Title of Report:	Planning Committee Report - LA01/2021/1173/F
Committee Report Submitted To:	Planning Committee
Date of Meeting:	25 October 2023
For Decision or For Information	For Decision – Council Interest Item

App No: LA01/2021/1173/F Ward: Waterside

Address: Land opposite nos 2 & 2A and at Laurel Park, Coleraine

Proposal: Proposed access road including access alterations along Laurel Park, Coleraine to service social housing zoning - CEH55 in Northern Area Plan 2016

Site Block Plan

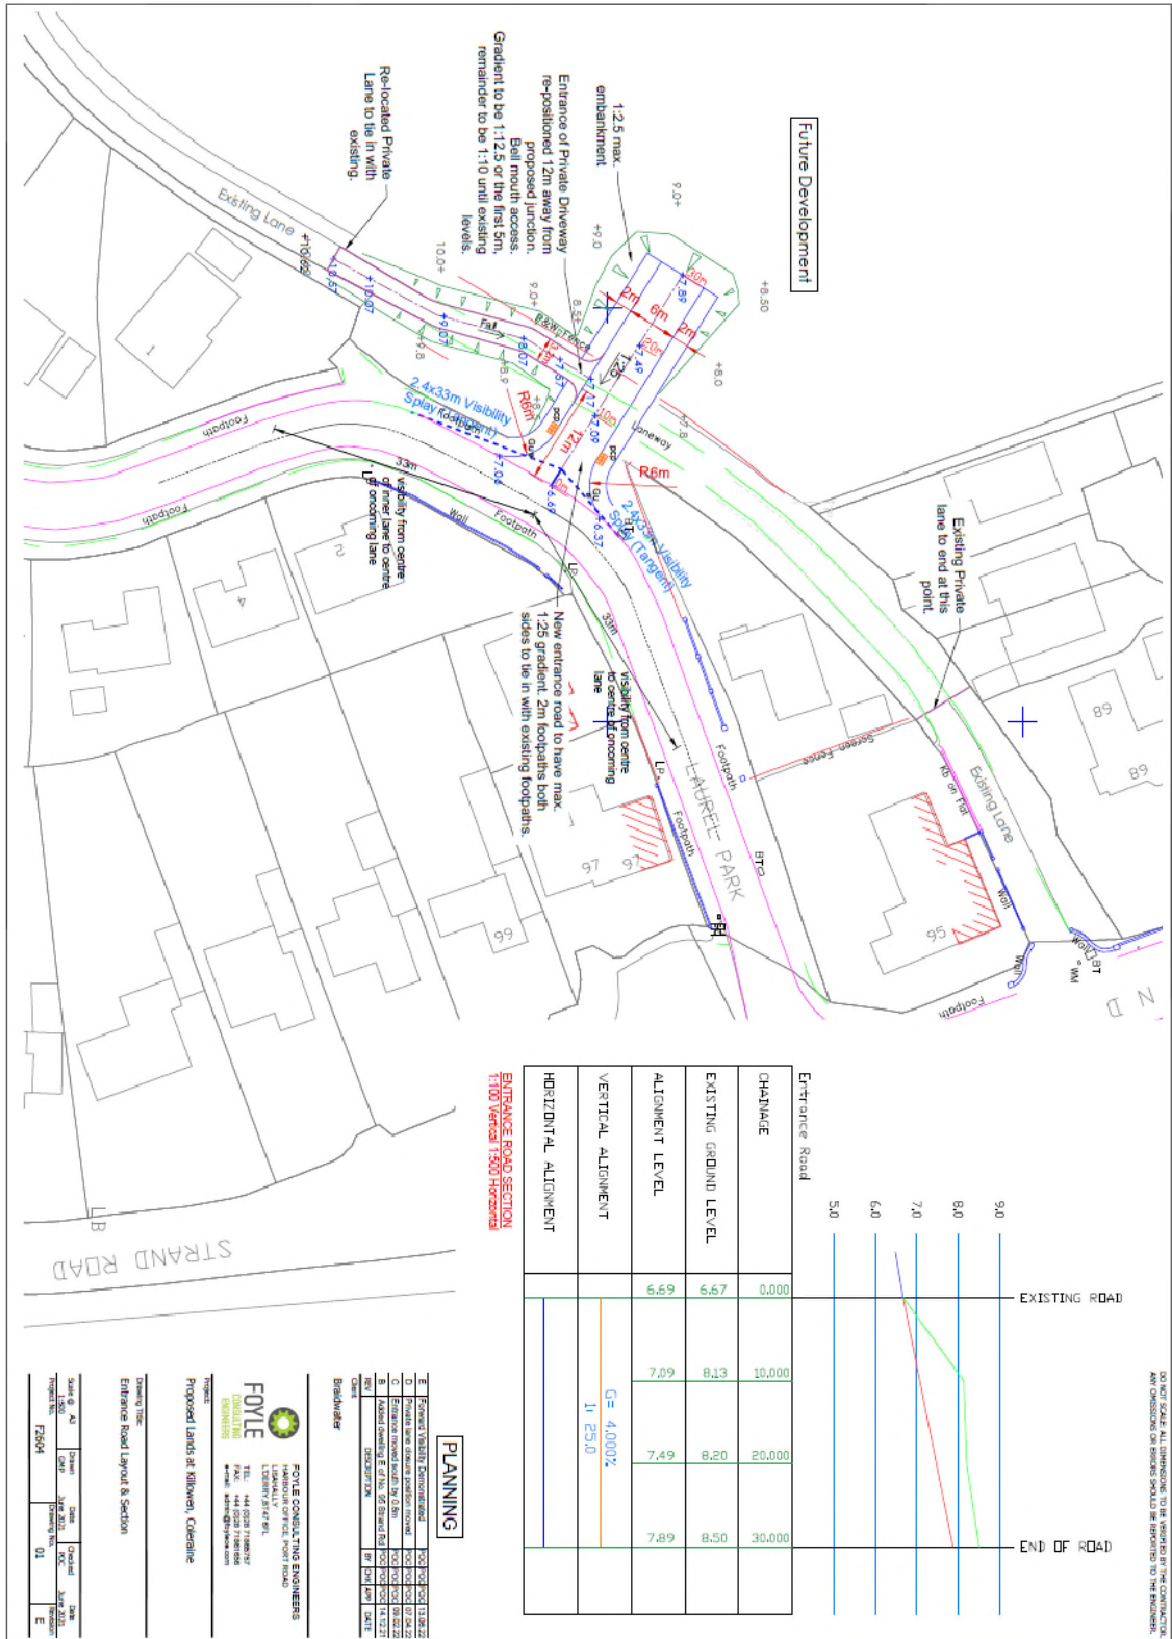
- 2.22 Green lines are noted on the site layout plan as raised by No. 2 Laurel Park as crossing into their ownership. These lines are indicative of road geometry only and indicate the edge of the grass verge and the pavement at No. 2.

Members asked if the boundary of the neighbouring development would be affected. The plan was shown of the access and splays that do not affect the property.
